**Re: Defect Information Report – Supplemental Report No. 4
07V-306, FL-501, AAC Front Axle Steering Arm Bolts**

**Recall Notification
Subject: AAC Front Axle Tie Rod and Steering Arm Fasteners**

**Re: Defect Information Report – Supplemental Report No. 3
07V-306, FL-501, AAC Front Axle Steering Arm Bolts**

Re: Defect Information Report FL-501, AAC axle Steering Arm Bolts

Fig. 1, Steering Arm and Tie Rod Arm

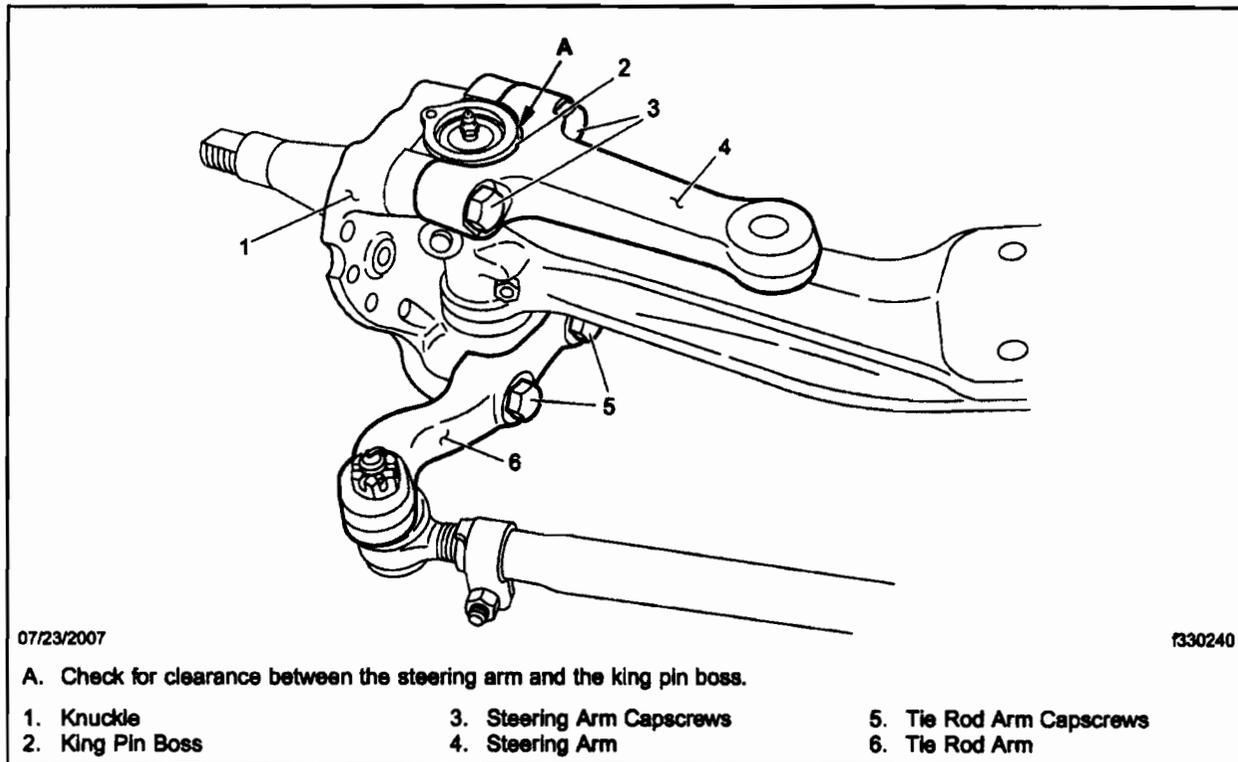
During front axle assembly, the fasteners that attach the steering arm or the tie rod arms to the spindle may have been over or under tightened. Incorrectly tightened fasteners may fatigue and fracture, resulting in a possible vehicle crash without prior warning.

1. Check the base label (Form WAR259) for a completion sticker for FL501 (WAR260) indicating this work has been done. The base label is usually located on the passenger-side door about 12 inches (30 cm) below the door latch on trucks, over the driver's window in school buses, on the front wall under the dash in motorhomes, or in the driver's area in step vans. If a completion sticker for FL501 is present, nothing more needs to be done. If no sticker is present, go to the next step.
2. Shut down the engine, and chock the front tires.
3. Using a 0.004 inch (0.1 mm) feeler gauge, check the clearance between the steering arm and the king pin boss. See Fig. 1.

1. Remove one of the capscrews that attaches the steering arm to the steering knuckle. See Fig. 1.
2. Check the capscrew threads to verify whether Loctite® or another thread locking compound was applied to them.

1. Remove one of the capscrews that attaches the tie rod arm to the knuckle. See Fig. 1.
2. Check the capscrew threads to verify whether Loctite® or another thread locking compound was applied to them.

3. Apply Loctite 277 to the threads of a new M20 x 1.5 x 80 capscrew from the Recall kit.
4. Install the new steering arm capscrew and tighten it 425 lbf-ft (575 N-m).
5. Repeat steps 1 through 4 to replace the second capscrew.
6. Continue with the "Tie Rod Arm Capscrew Replacement" procedure in these Work Instructions.

3. Apply Loctite 277 to the threads of two new M20 x 1.5 x 80 capscrews.
4. Install a new steering arm with its engraved part number facing upward.
5. Install the new steering arm capscrews and tighten them 425 lbf-ft (575 N-m).
6. Go to the "Tie Rod Arm Capscrew Replacement" procedure in these Work Instructions.

Figure 1

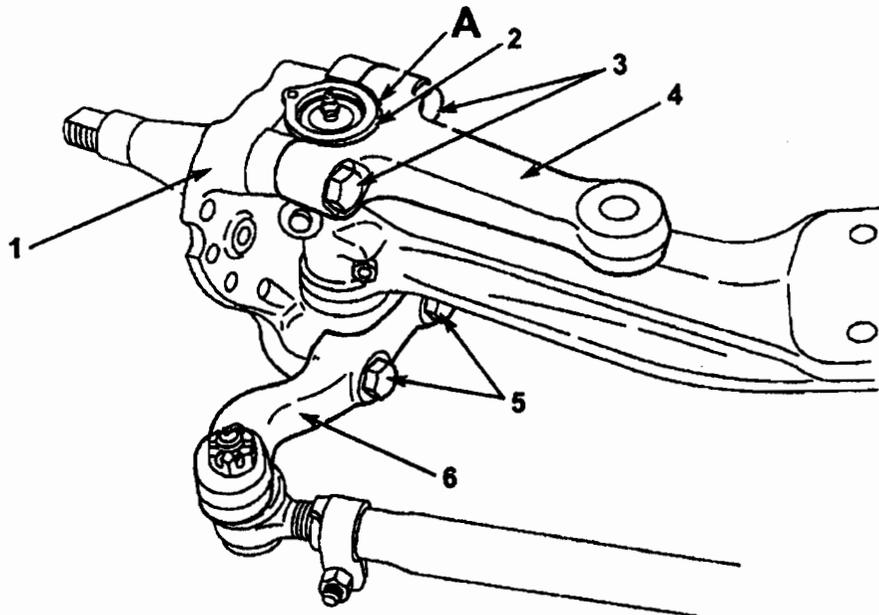
The defect involves the fasteners that attach the steering arm or tie rod arms to the spindle. During front axle assembly these fasteners may be over or under tightened. Incorrectly torqued steering arm fasteners may fatigue and fracture, causing loss of steering, and a crash without warning.

1. Shut down the engine, and chock the front tires.
2. Using a 0.004" (0.1 mm) feeler gauge, check the clearance between the steering arm and the king pin boss. **Figure 1**

A. Check for clearance between the steering arm and the king pin boss.

1. Remove one of the capscrews that attaches the steering arm to the steering knuckle. **Figure 1**
2. Check the capscrew threads to verify whether Loctite® or another thread locking compound was applied to them.

1. Remove one of the capscrews that attaches the tie rod arm to the knuckle. **Figure 1**
2. Check the capscrew threads to verify whether Loctite® or another thread locking compound was applied to them.

3. Apply Loctite 277 to the threads of a new M20 x 1.5 x 80 capscrew from the Recall Kit.
4. Install the new steering arm capscrew and tighten it 425 ft/lbs. (575 N·m).
5. Repeat steps 1 through 4 to replace the second capscrew.
6. Continue with the "Tie Rod Arm Capscrew Replacement" procedure.

3. Apply Loctite 277 to the threads of a new M20 x 1.5 x 80 capscrew.
4. Install the new tie rod arm capscrew and tighten it 425 ft/lbs. (575 N·m).
5. Repeat steps 1 through 4 until all four of the tie rod arm capscrews have been replaced.
6. Remove the chocks.

3. Apply Loctite 277 to the threads of two (2) new M20 x 1.5 x 80 capscrews.
4. Install a new steering arm with its engraved part number facing upward.
5. Install the new steering arm capscrews and tighten them 425 ft/lbs. (575 N·m).
6. Go to the "Tie Rod Arm Capscrew Replacement" procedure found on page 2 of this document.
